Date: June 20, 2008
To: Rick Brown, Planning Director
From: Hans Larsen, Executive Director 
RE: 978 Worcester Street PSI Traffic Study

Re: Proposed Mixed-Use Development
978 Worcester Street (Route 9)
Wellesley, Massachusetts

Re: **Wellesley – Traffic Peer Review for Proposed Mixed Use Development at 978 Worcester Street—Response to 4/18/08 Supplemental Traffic Impact Assessment & 4/18/08 Parking Analysis**

97A WORCESTER STREET
REDEVELOPMENT PROJECT
IN THE TOWN OF
WELLESLEY, MASSACHUSETTS
PROPOSED SIGNAGE &
ACCESS PLAN

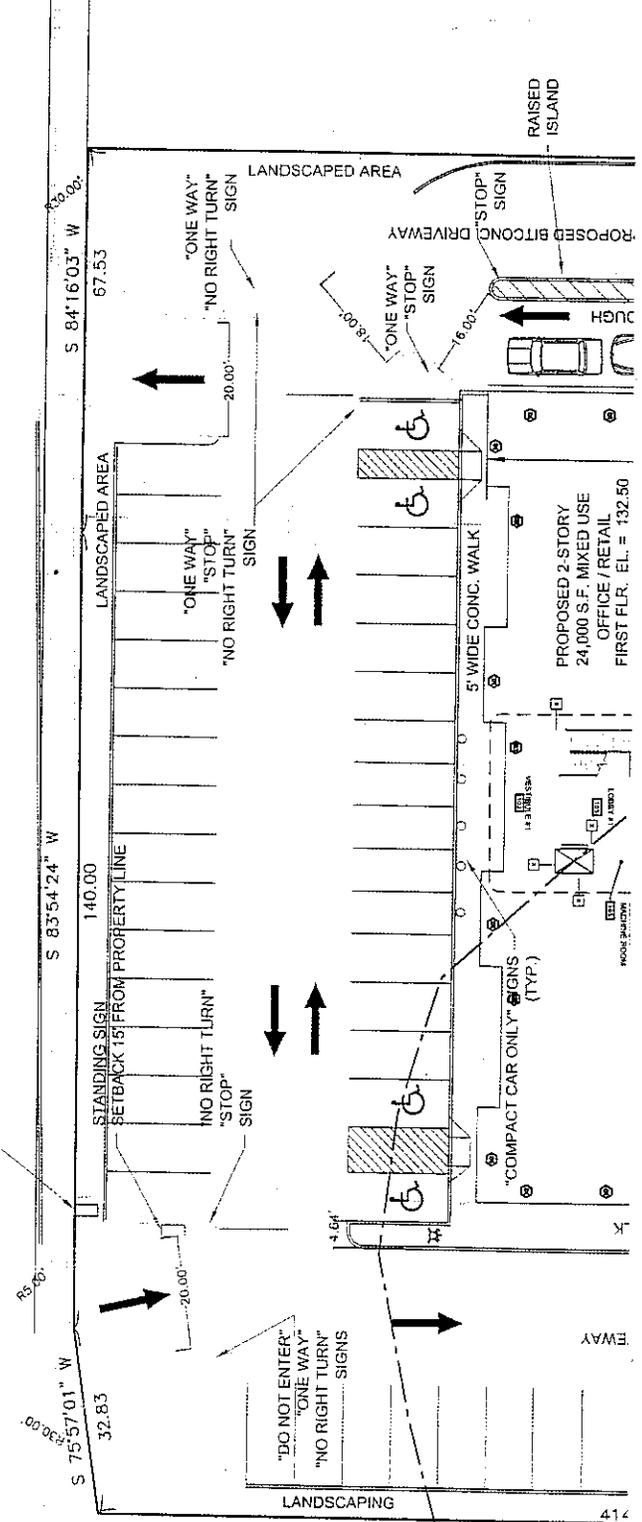
We are comfortable with the revised egress design and have minor comments on the revised egress driveway (see attached sketch). We recommend that the "island" be modified to provide the following :

1. the stop bar for the eastbound travel direction will be inside the parking lot instead of outside or in the egress roadway.
2. ensure that the right turn is physically restricted.

The island modification is necessary from a safety standpoint and will loose one parking space with the handicapped space being shifted to the east.

The January 15, 2008 site plans shows the westerly site driveway as one way in only and the easterly site driveway as one way out only. However, the analysis in the report shows both driveways being two way. This should be resolved and corrected analysis shown.

The report states that four vehicle storage will be provided for the Starbucks drive-thru. This should be shown on the site plan and the storage area should not conflict with parking areas. Queue analysis should be provided for our review to ensure the queue does not back up to Route 9.
